ADDENDUM NUMBER 003

1.02 PROJECT: MSCR WEST RECREATION CENTER EXPANSION

CLARIFICATIONS TO ADDENDUM BP1A1, BID QUESTION/RESPONSE LOG

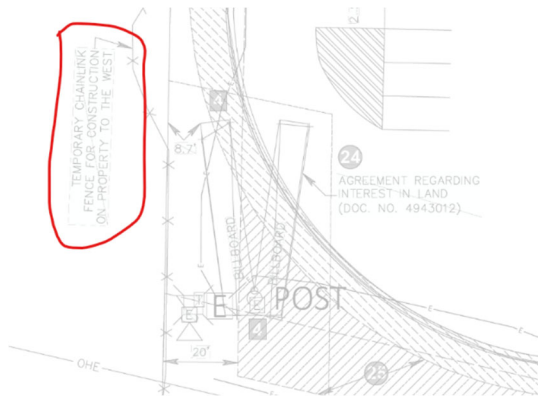
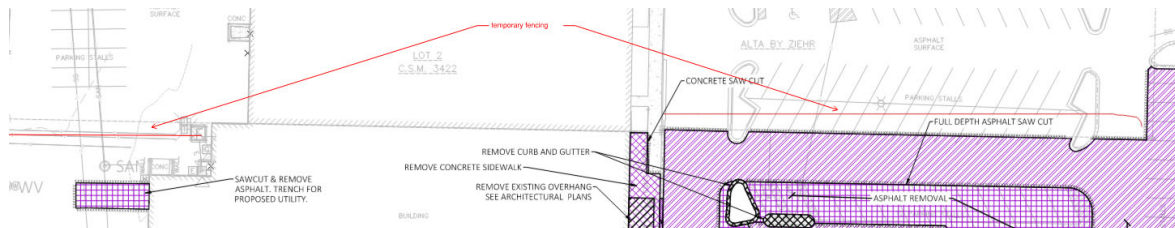
I see in the addendum now that it appears temporary fencing is required (noted in the bottom left corner of C002 also). Is this what we are to follow? It almost seems like this note was copied from the land plat/title survey back in 2024.

Or is this plan below for temporary fencing what we need to include?

Given this is an active shopping mall environment, the temporary fencing plans included within the construction documents are more representative of the intended application and project needs.

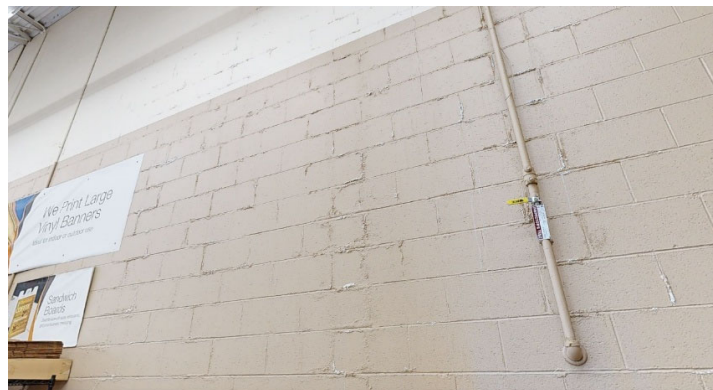
RFI Question 74 talks about what should be done at the exterior wall where moisture appears to be coming through. The RFI answer is "IMAGE." There is no attachment or link provided. Please clarify.

The architect's response to this question only says "IMAGE". Any chance you've seen the referenced image? I do not see this in any of the files they provided.

The image below shows existing conditions only and is not intended to represent a proposed solution. The architect's recommended resolution is to clean the inside face of the CMU where efflorescence appears.
